McKinleyville Community Services District McKinleyville BMX and Park Project

Bid Addendum #1

Date of Issue: 19 April 2024

6 ASPHALT TURNS-BID ALT. 11 SCALE N.T.S.

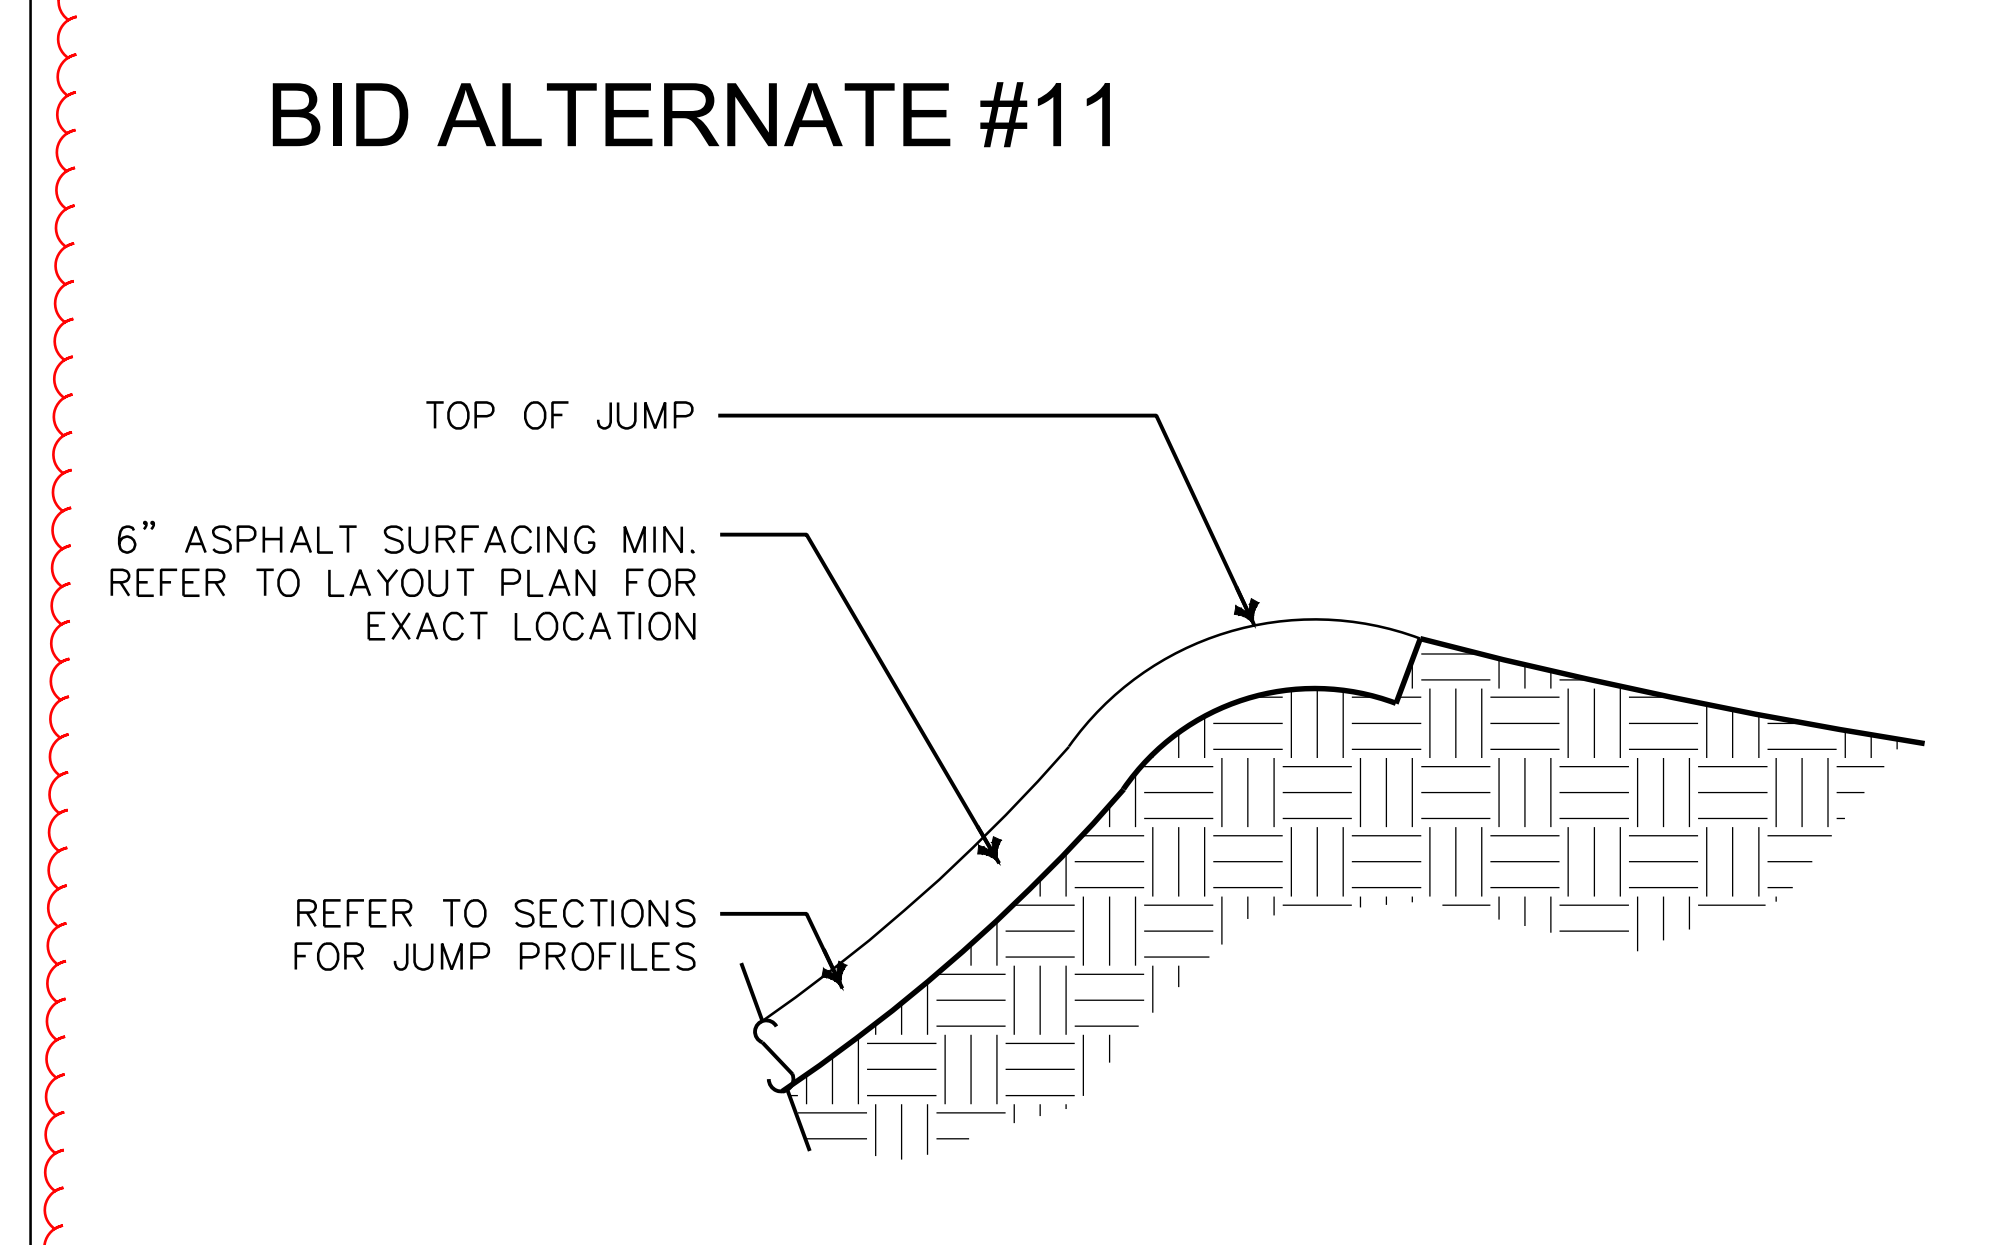
31. Sheet BT-7.01 Detail 5 and 6 reference " Bid Alternate #1". Where is this addressed in the Track bid item(s)

RESPONSE: The referenced "Bid Alternate #1" is called out (as #9) on sheet BT1.01 and has been added to the Bid Form and Measure and Payment section of the Contract Documents as item A-11 as of this addendum.

Sheet BT7.01 - Details Details 5 and 6 have been edited.

2 POUR IN PLACE RUBBER
L2.2 1/8" = 1'

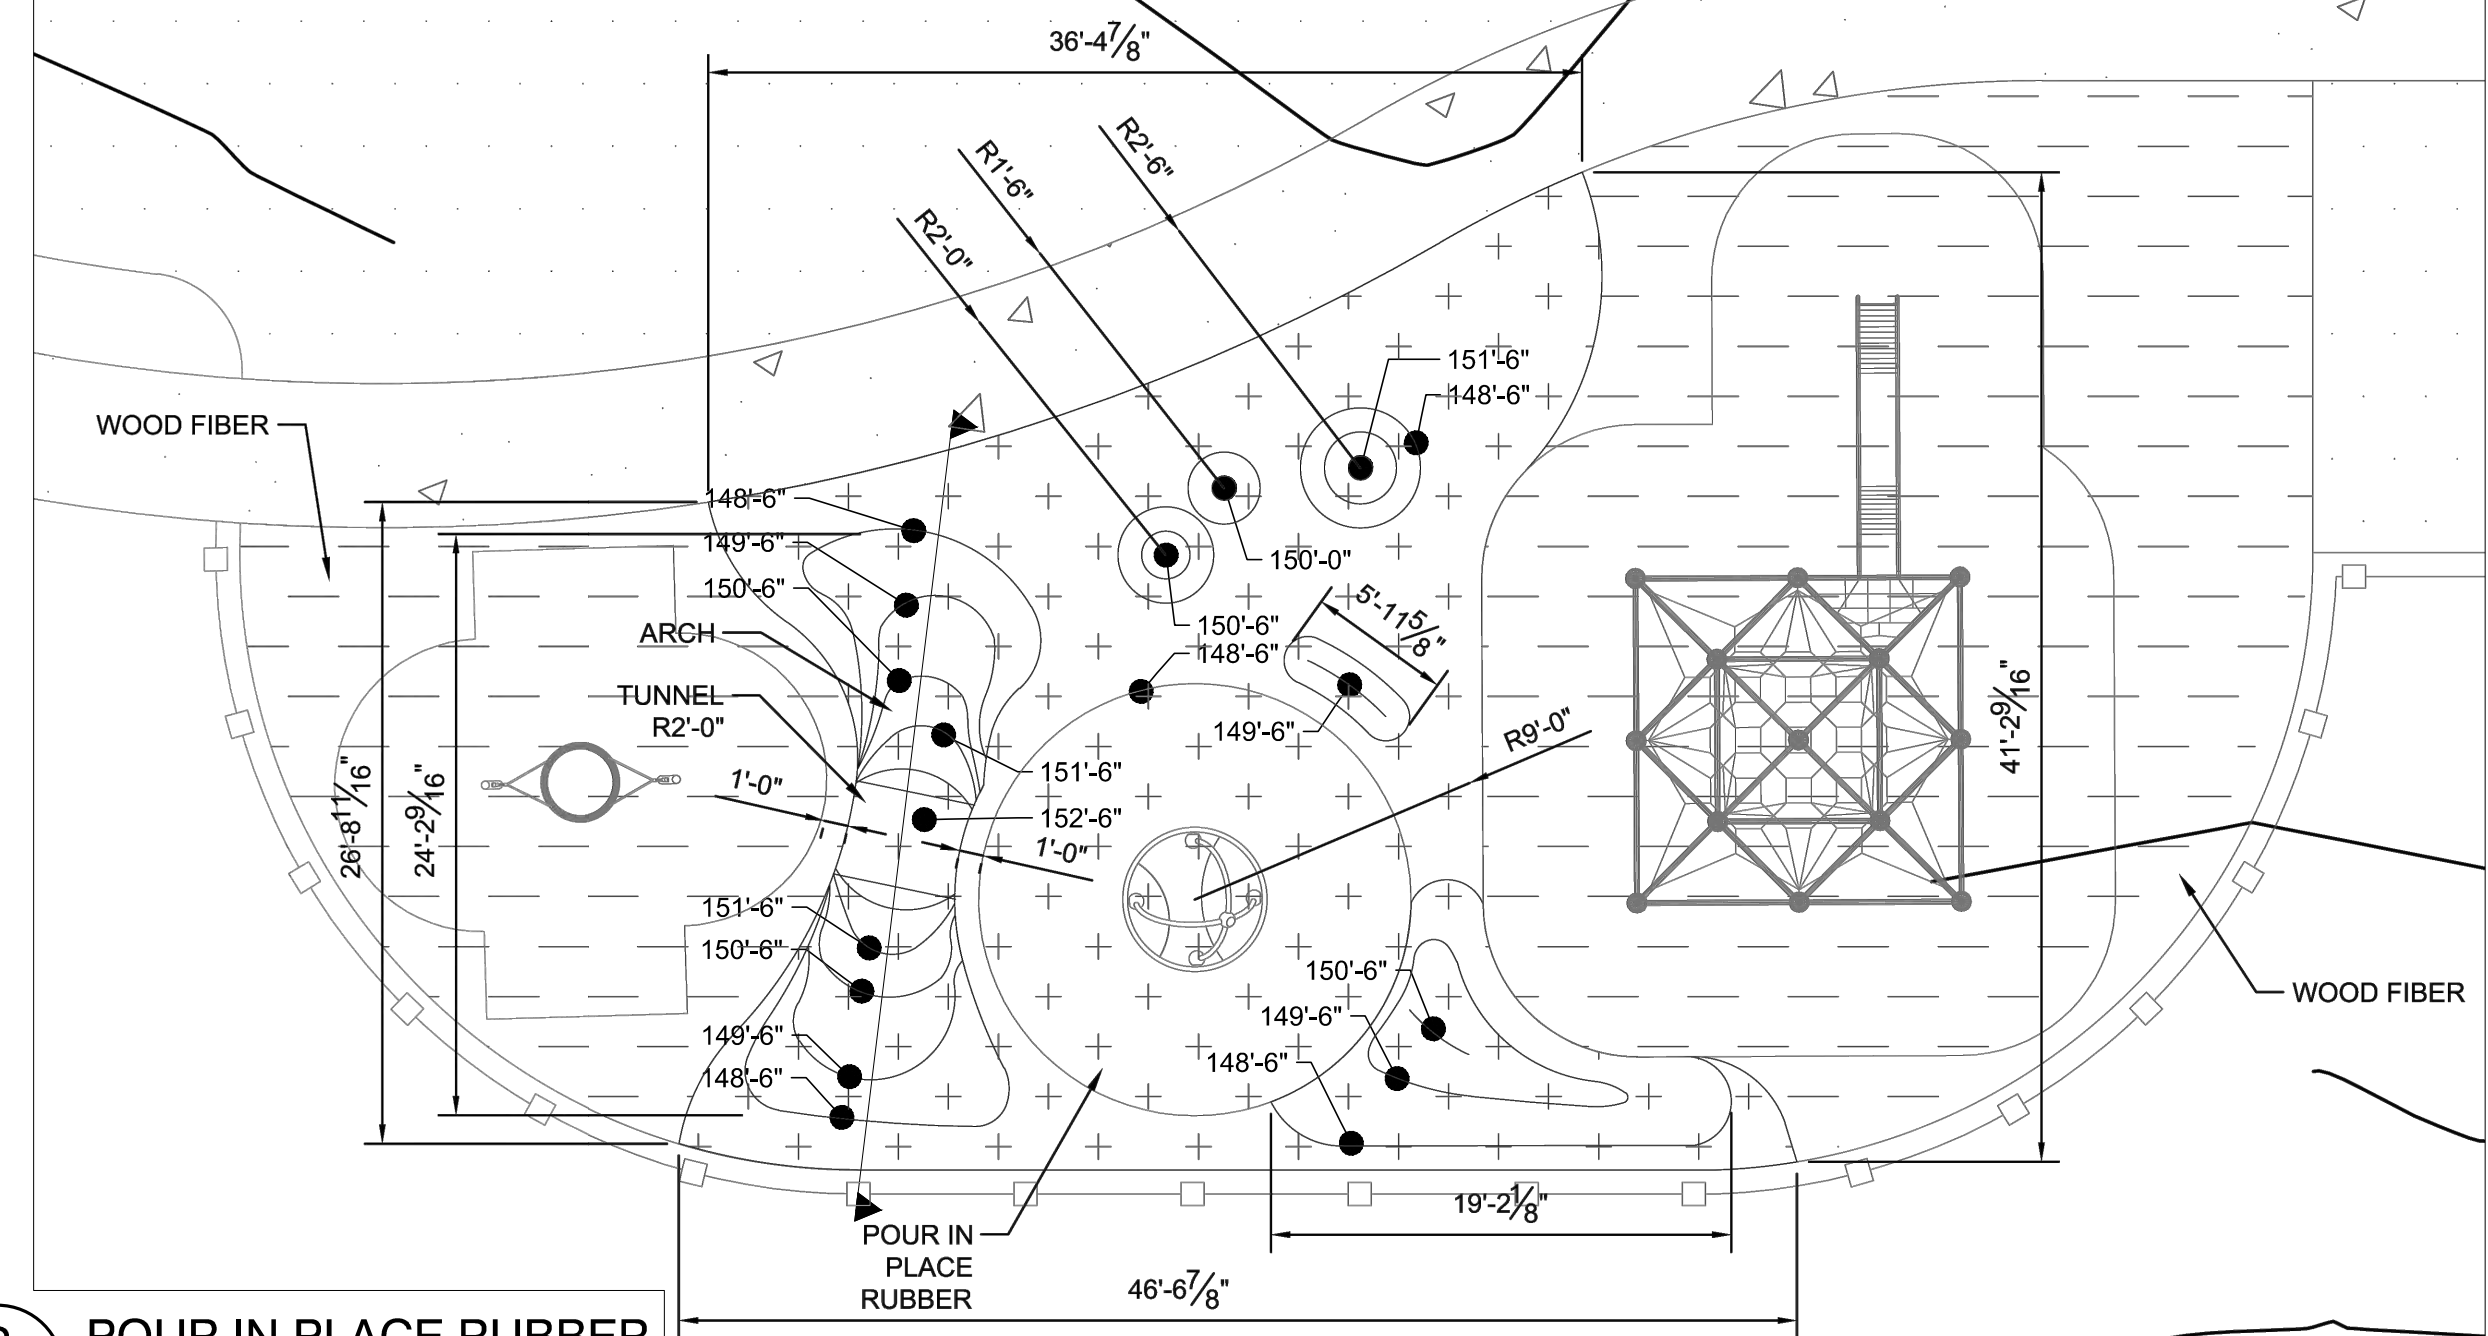
a. Surface depth or play structure fall height?

RESPONSE: For surface depth and equipment fall heights refer to details 2,3,and 8 on sheet L2.2 and equipment cut sheets included with this addendum. The spinner (Picadilly Circle) is the only piece of equipment located within Pour-In-Place Rubber.

4 48" DIAMETER MANHOLE SHAFTING
L2.2 NTS

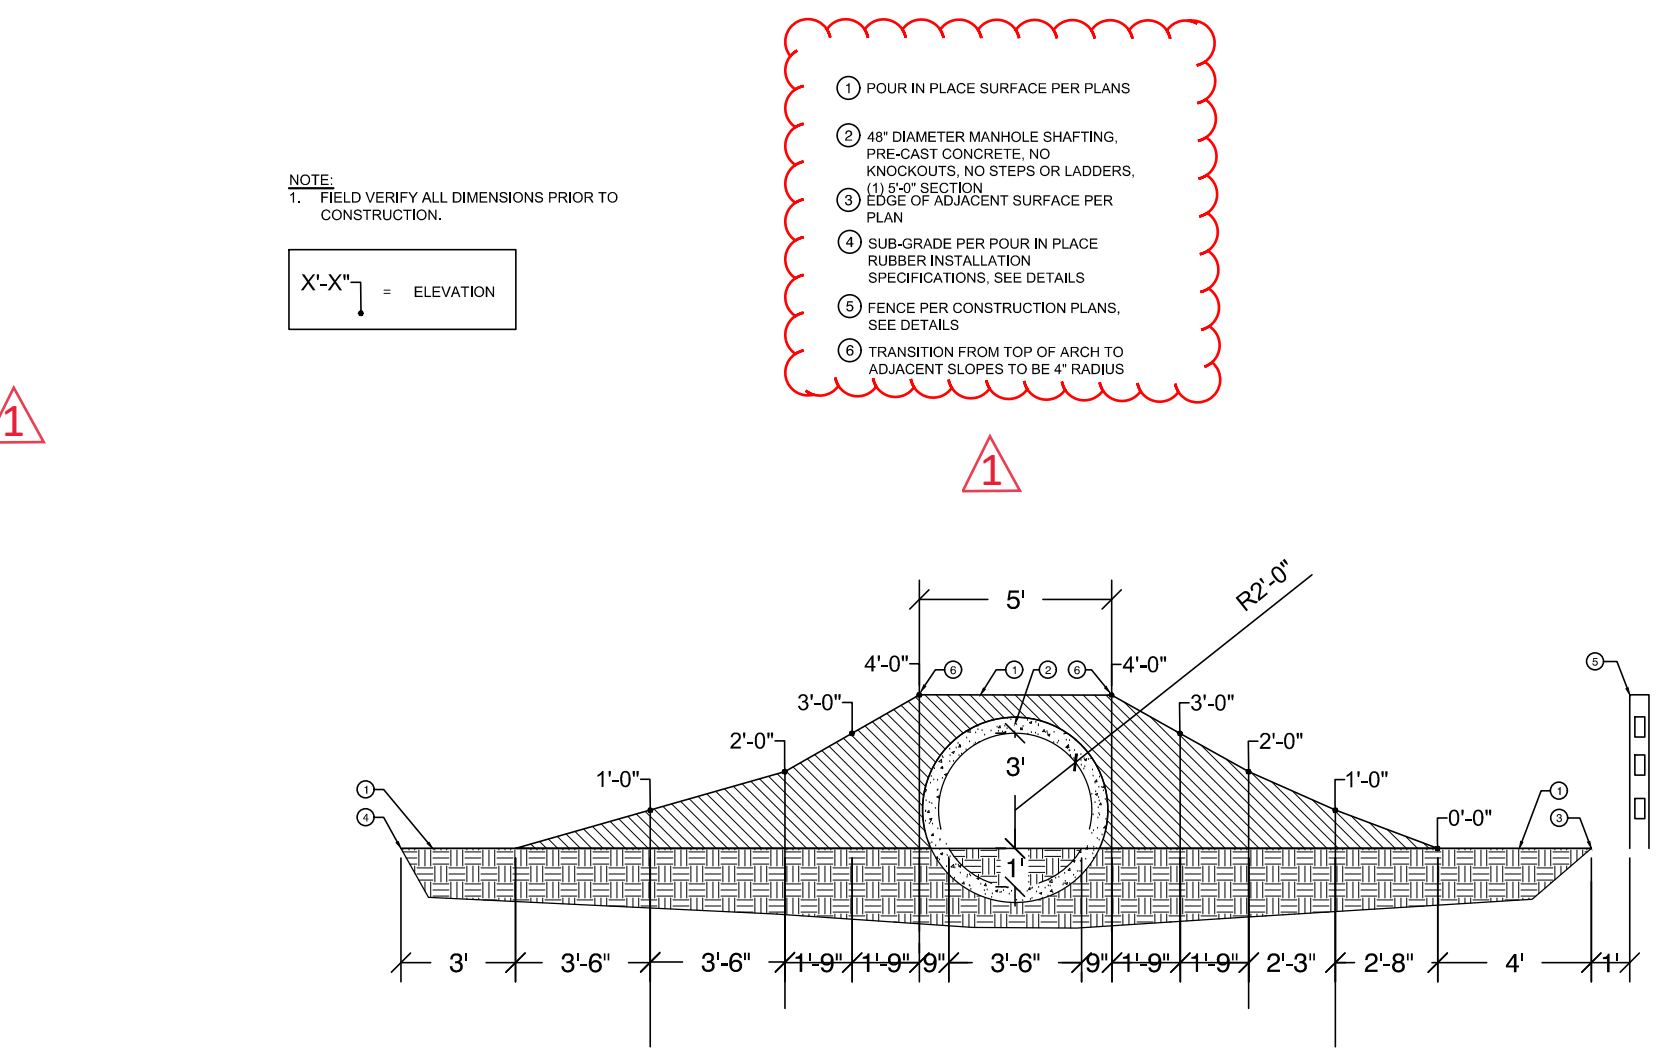
25. Detail 4 on L2.2 shows a typical 48" dia. base for SS manhole. What is the one Mickey Mouse ear depicting?

RESPONSE: Details 3 and 4 on sheet L2.2 have been revised with this addendum.

Sheet L2.2 – Construction Details: Details 3 and 4 have been edited.

3 POUR IN PLACE RUBBER - SECTION THROUGH TUNNEL
L2.2

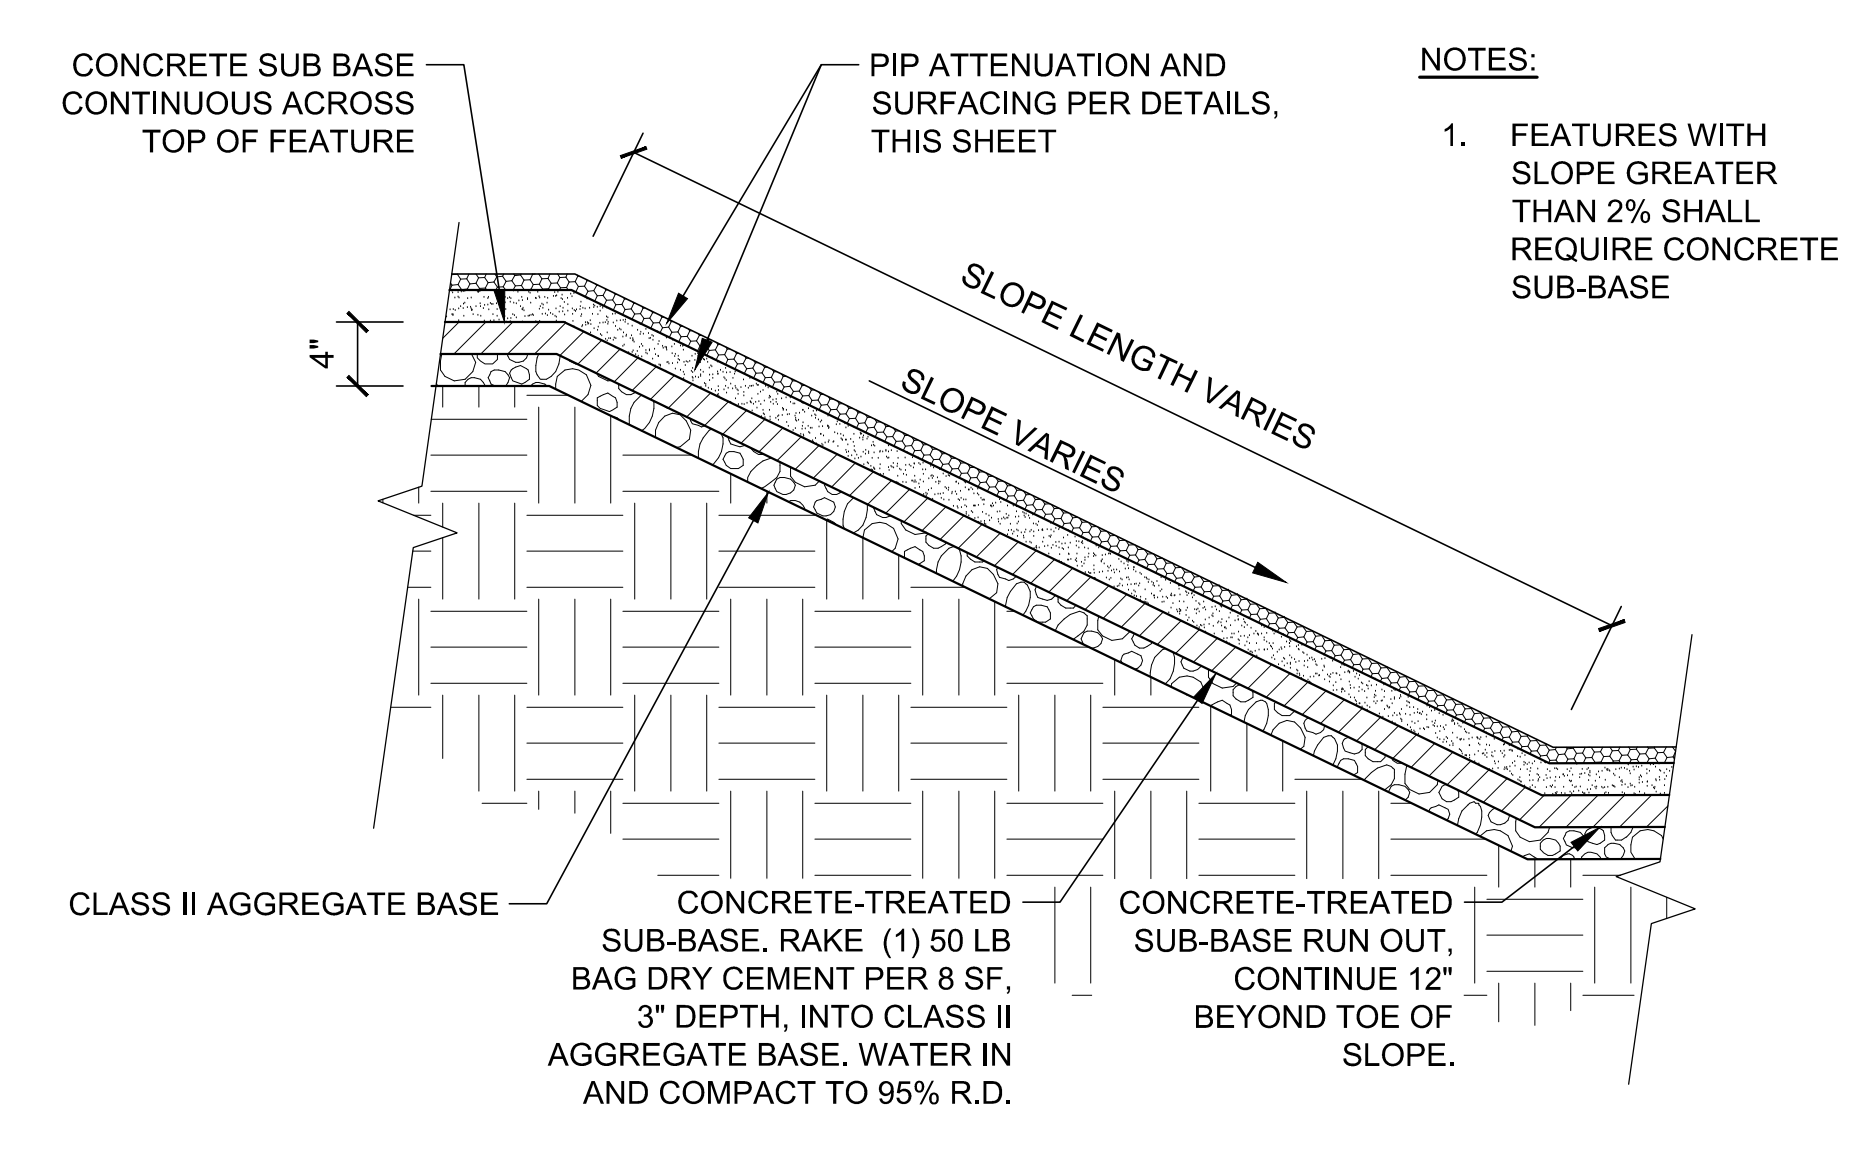
Detail 3 says - 48" DIAMETER STOCK MANHOLE BASE,
PRE-CAST CONCRETE, NO
KNOCKOUTS, (2) 2'-6" SECTIONS

These two base unit pieces combined do not constitute a "tunnel". What is the actual length of the "tunnel"? 8' ? or 4'?

Response: 60"
